Access Compliance Report

Public Rights-of-Way

(Curb Ramps)

Intersection ID: 46147	Main Street: ROCKY_FORD_CLUB_RD	Cross Street: ARBOR_CREEK_DR	Location: NE
ADA ID: A239E436A17A	Ramp Type: BlendTrans1	Initial Pass/Fail: Fail	Overall Compliance: No
Severity Score: 1.25			
Codes/Mitigation Info/Possible Solution		Field Measurements/Component Compliance

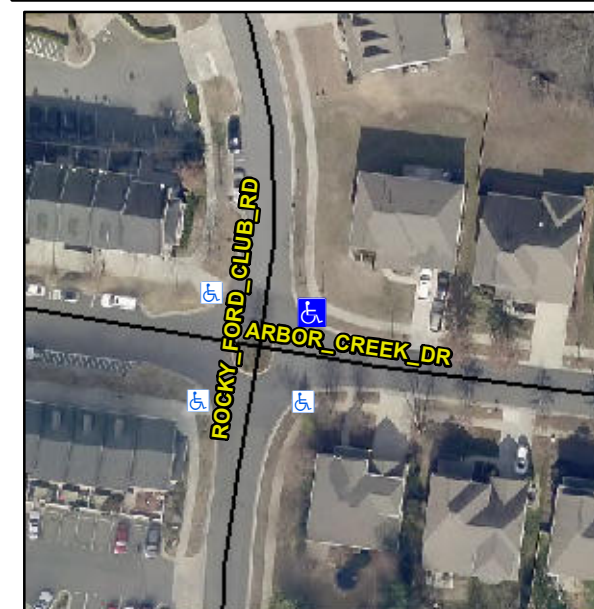
CURB UNMODIFIED

Not Found, R304.5.3

Compliance	Description	Data	Compliance	Description	Data
N/A	Ramp Length (in)	72.0	Yes	BlendTrans Slope (%)	2.2
Yes	Ramp Width (in)	48.0	No	BlendTrans XSlope (%)	4.3
N/A	Flare Type LT	N/A	N/A	Flare Type RT	N/A
N/A	Flare Slope LT (%)	N/A	N/A	Flare Slope RT (%)	N/A
N/A	Flare Traversable LT?	N/A	N/A	Flare Traversable RT?	N/A
N/A	Landing Length (in)	N/A	N/A	DWS Provided?	N/A
N/A	Landing Width (in)	N/A	N/A	DWS Contrast?	N/A
N/A	Landing Slope (%)	N/A	N/A	DWS Length (in)	N/A
N/A	Landing X Slope (%)	N/A	N/A	DWS Full Width?	N/A
N/A	Landing Curb? (Y/N)	N/A	N/A	DWS Offset (in)	N/A
N/A	Shared Landing?	N/A			
N/A	Gutter Ponding?	N/A	N/A	Gutter Slope (%)	N/A
N/A	Gutter Lip Ht (in)	N/A	N/A	Gutter X Slope (%)	N/A
N/A	Painted X Walk1?	No	N/A	Painted X Walk2?	No
	X Walk 1 Direction	To W		X Walk 2 Direction	To S
	X Walk 1 Width (in)	N/A		X Walk 2 Width (in)	N/A
	X Walk 1 Slope (%)	4.2		X Walk 2 Slope (%)	2.9
	X Walk 1 X Slope (%)	2.0		X Walk 2 X Slope (%)	3.4

N/A	Ramp inside XWalk1?	N/A	N/A	Ramp inside XWalk2?	N/A
	Road Slope (%)	3.9		Clear Space?	N/A
	Road X Slope (%)	1.1	N/A	Clear Space to XWalk (in)	N/A
N/A	Any Obstructions?	N/A	N/A	Storm Grate/Utility Hazard?	N/A
	Obstruction Type			Storm Grate/Utility Type	
		N/A			N/A
			Yes	Surface Condition? (G/P)	Good
			No	Curb Slope (%)	26.8

Remove & Replace Curb Ramp With Two New Directional Ramps or Equivalent.
